Overall Project Development Budget

ROM Plaza Pause Option

PLAZA PAUSE OPTION

| BROWARD COUNTY CONVENTION CENTER - PLAZA Ft. Lauderdale, Florida BUDGET 2/17/2021 | TOTAL |

Supporting Documents

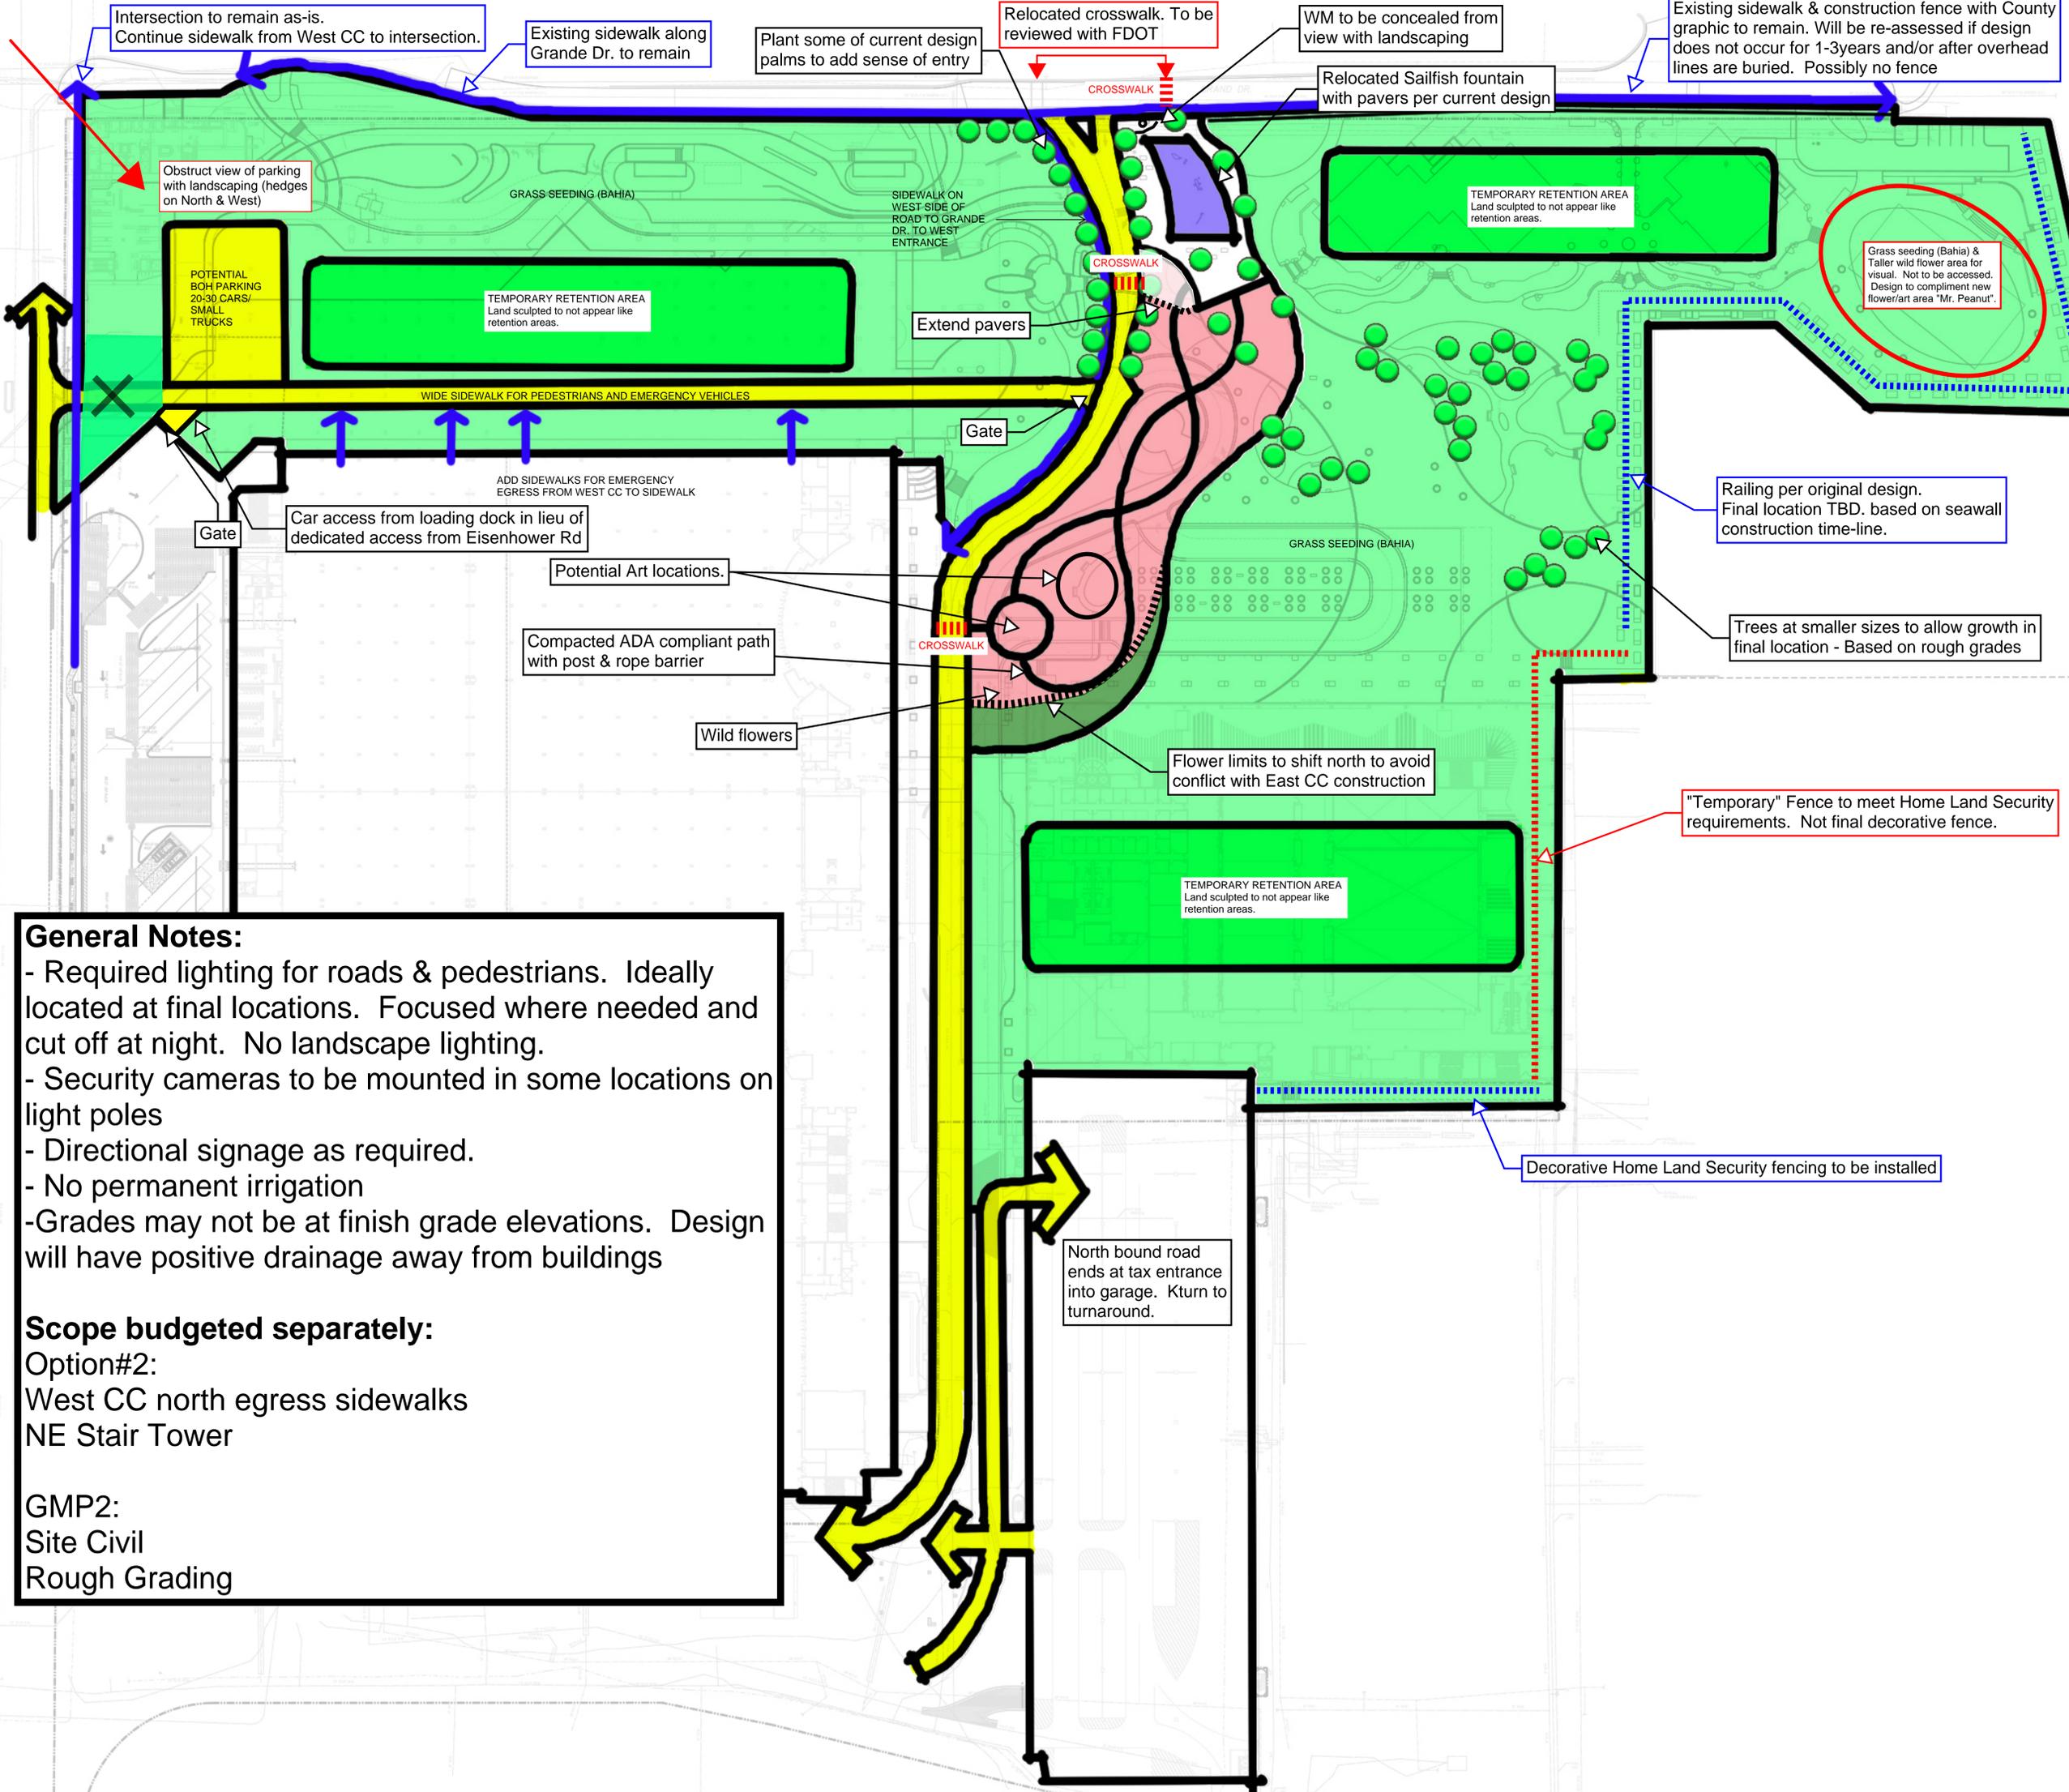
Intersection to remain as-is. Continue sidewalk from West CC to intersection.

Existing sidewalk along Grande Dr. to remain

Plant some of current design palms to add sense of entry

Relocated crosswalk. To be reviewed with FDOT

WM to be concealed from view with landscaping

Existing sidewalk & construction fence with County graphic to remain. Will be re-assessed if design does not occur for 1-3years and/or after overhead lines are buried. Possibly no fence

Obstruct view of parking with landscaping (hedges on North & West)

POTENTIAL BOH PARKING 20-30 CARS/ SMALL TRUCKS

TEMPORARY RETENTION AREA Land sculpted to not appear like retention areas.

SIDEWALK ON WEST SIDE OF ROAD TO GRANDE DR. TO WEST ENTRANCE

Extend pavers

Relocated Sailfish fountain with pavers per current design

TEMPORARY RETENTION AREA Land sculpted to not appear like retention areas.

Grass seeding (Bahia) & Taller wild flower area for visual. Not to be accessed. Design to compliment new flower/art area "Mr. Peanut".

WIDE SIDEWALK FOR PEDESTRIANS AND EMERGENCY VEHICLES

ADD SIDEWALKS FOR EMERGENCY EGRESS FROM WEST CC TO SIDEWALK

Car access from loading dock in lieu of dedicated access from Eisenhower Rd

Potential Art locations.

Compacted ADA compliant path with post & rope barrier

Wild flowers

Flower limits to shift north to avoid conflict with East CC construction

Railing per original design. Final location TBD. based on seawall construction time-line.

Trees at smaller sizes to allow growth in final location - Based on rough grades

"Temporary" Fence to meet Home Land Security requirements. Not final decorative fence.

TEMPORARY RETENTION AREA Land sculpted to not appear like retention areas.

Decorative Home Land Security fencing to be installed

North bound road ends at tax entrance into garage. Kturn to turnaround.
